Sundry Notices and Reports on Wells

San Juan 27-4 U #105

**Attachment to Notice of
Intention to Workover**

**Re: Sidetrack
Well: 105 San Juan 27-4 Unit**

CURRENT WELLBORE SCHEMATIC

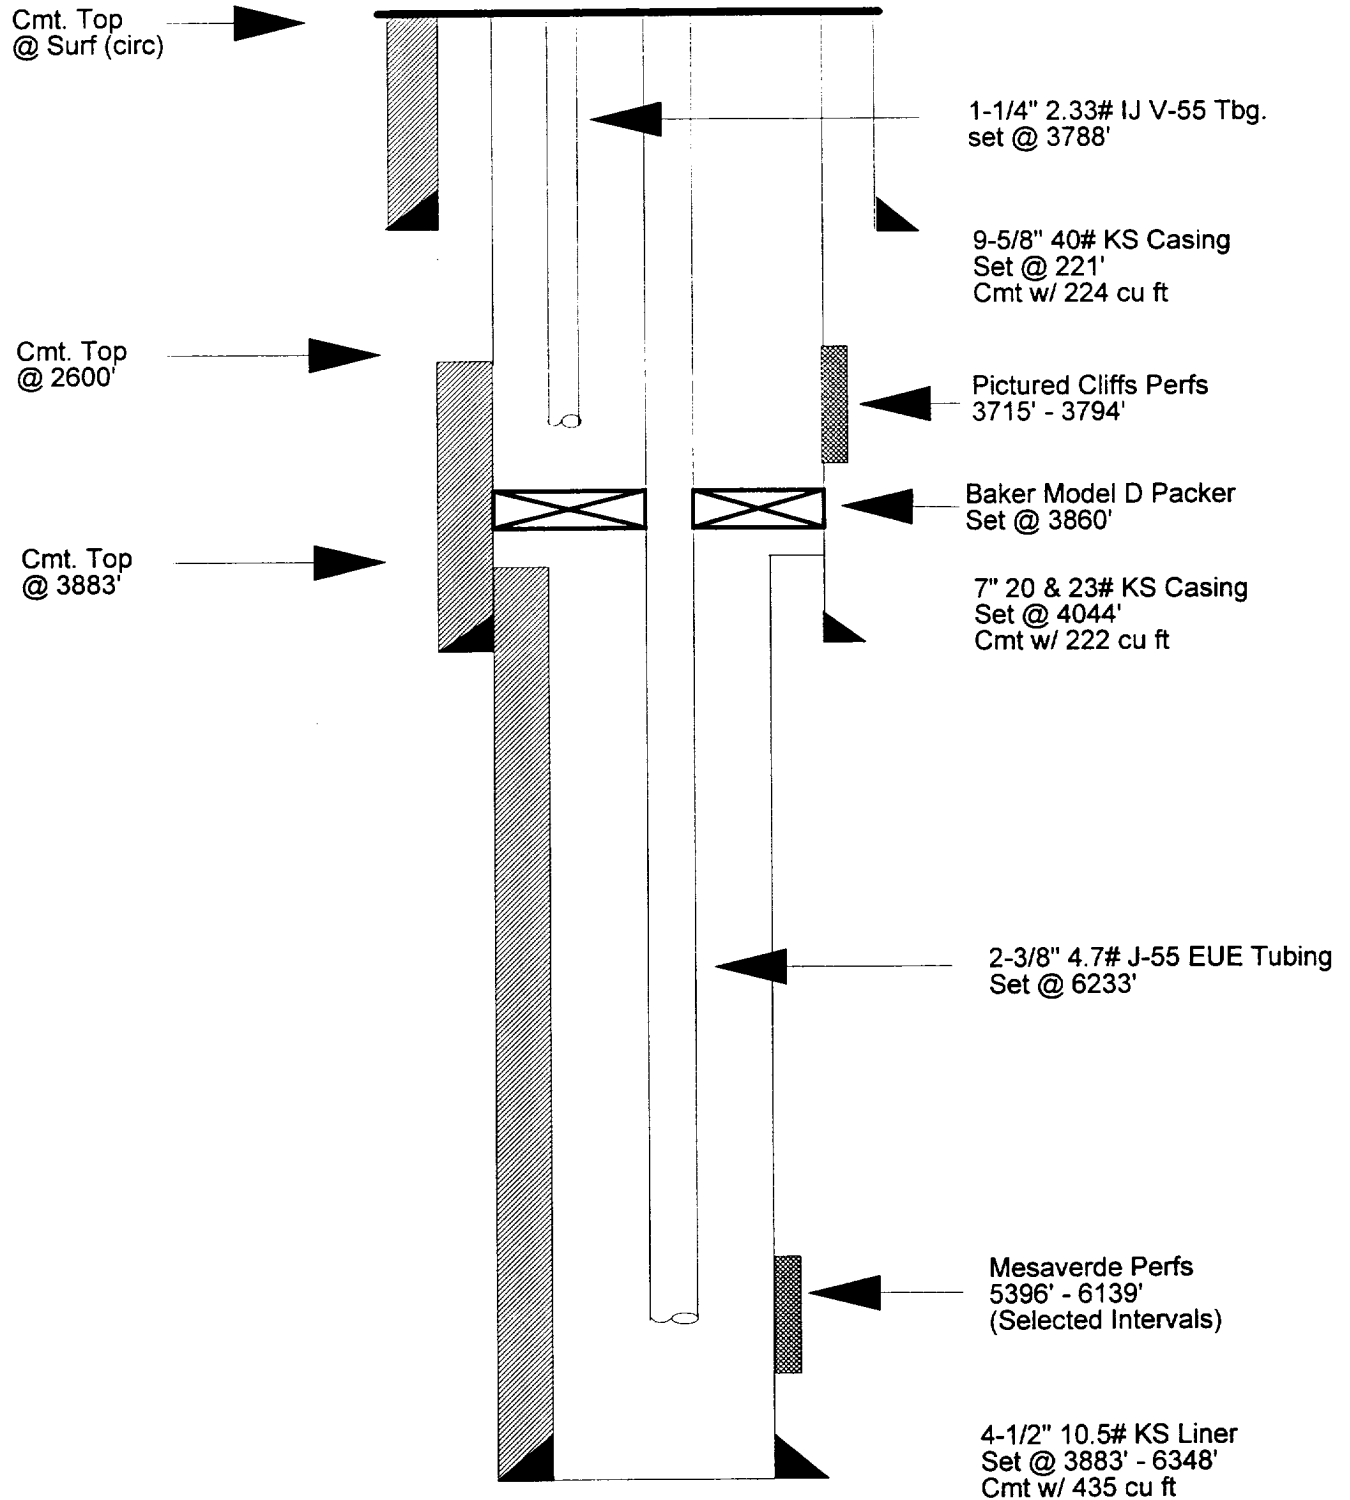
1. An additional cement plug is required from 4094' to 3833' inside the casing. (7" csg. set at 4044', TOL at 3883')
2. Recalculate the volume of cement to squeeze the Pictured Cliffs. (115 sxs.)
3. **Mike Flaniken** with the Farmington District Office is to be notified at least 24 hours before the workover operations commence (505) 599-8907.
